Compact Dishwasher

599 528 326 EN

Heating element 155 14 11 00/0 replaces heating elements 150 34 36 xxx

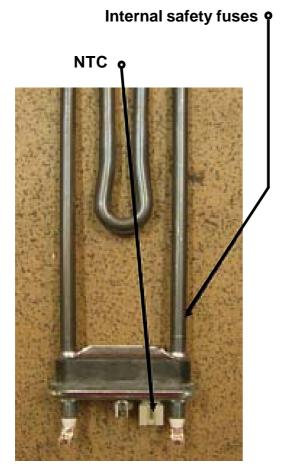
Replacement made by DP of the anc 150 34 36-xx with the new heater currently used in production 155 14 11-xx.

The old heater had visable safety fuses. The new heater is equipped with internal fuses. The new heater has also a built-in NTC. This is only used for fully electronic models.

It is OK to use this also for old electro-mechanial models. In this case the NTC is not connected.
